HISTORIC AND DESIGN REVIEW COMMISSION

May 16, 2018

HDRC CASE NO: 2018-222
ADDRESS: 619 BARBE ST
LEGAL DESCRIPTION: NCB 2877 BLK 2 LOT 14
ZONING: RM-4, H
CITY COUNCIL DIST.: 1
DISTRICT: King William Historic District
APPLICANT: Abraham Palacio
OWNER: Abraham Palacio
TYPE OF WORK: Remove collapsing portion of accessory structure to repair remaining portion.
APPLICATION RECEIVED: May 04, 2018
60-DAY REVIEW: July 03, 2018
REQUEST:

The applicant is requesting a Certificate of Appropriateness for approval to remove collapsing portion of an accessory structure to repair the remaining portion.

619 BARBE 50' x 125'

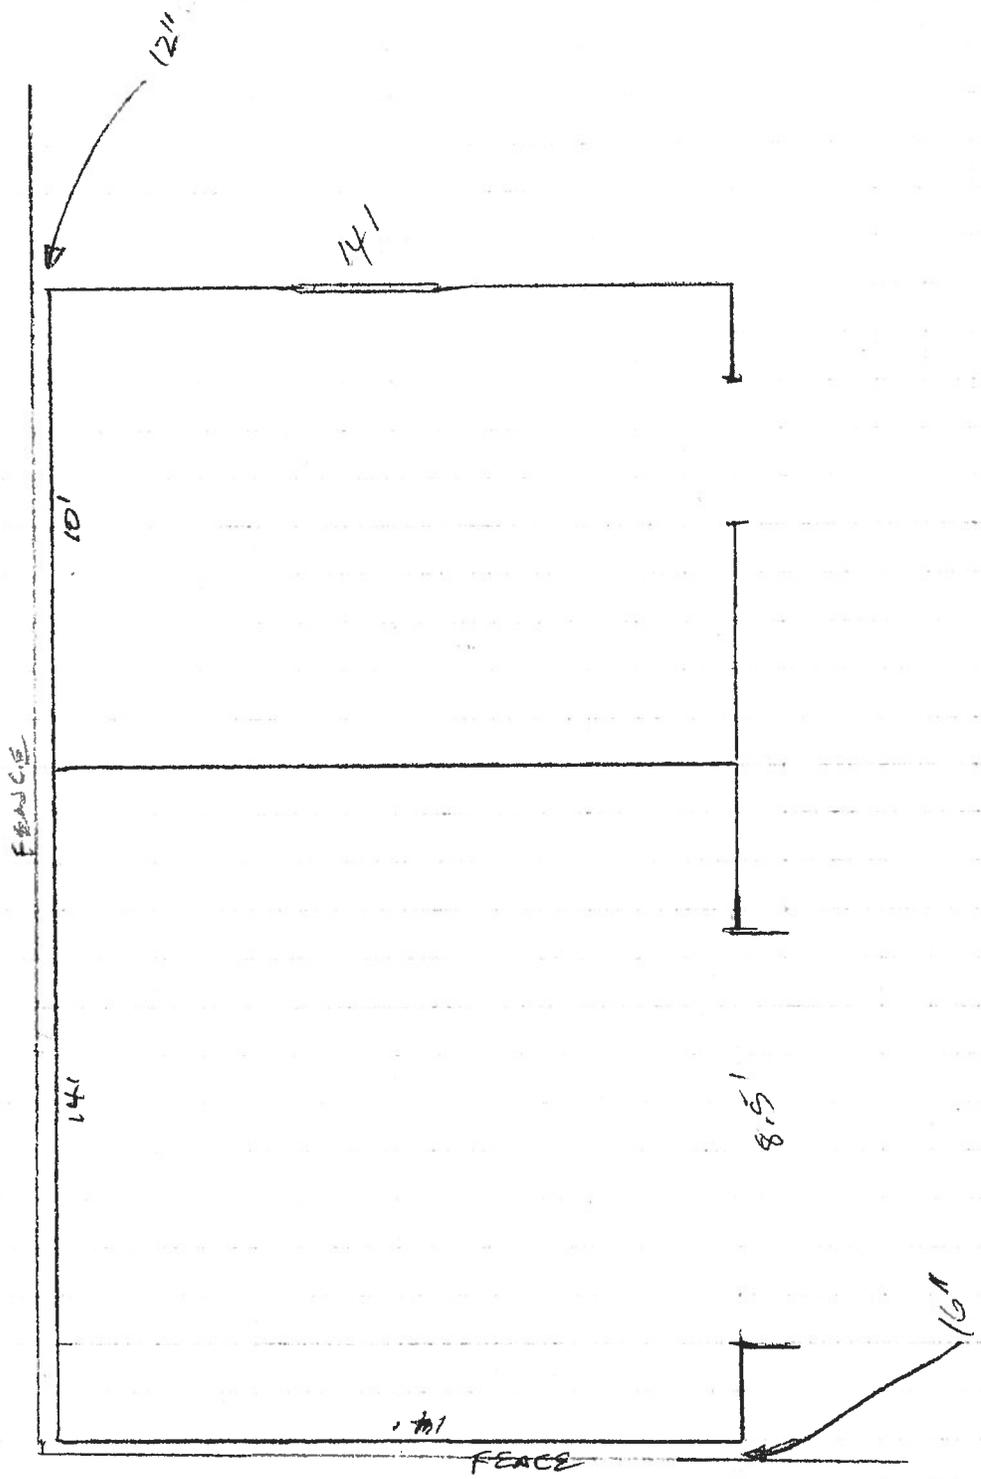
- b. **OUTBUILDING** – The applicant has proposed to demolish the collapsing 196 square feet portion of the accessory structure and use salvageable wood to repair the remaining 140 square feet. Staff finds this proposal generally consistent with the Guidelines due to the use of in-kind materials and no architectural changes to the structure except the reduction of square footage. When in-kind repair of the entire structure is not feasible, staff finds that the proposal to be an improvement from its current collapsing condition and is preferred over a total demolition.

Staff recommends approval based on finding b with the stipulation that there are no changes to the accessory structure besides the reduction of overall square footage; repairs of the remaining structure are to be performed with salvaged wood.
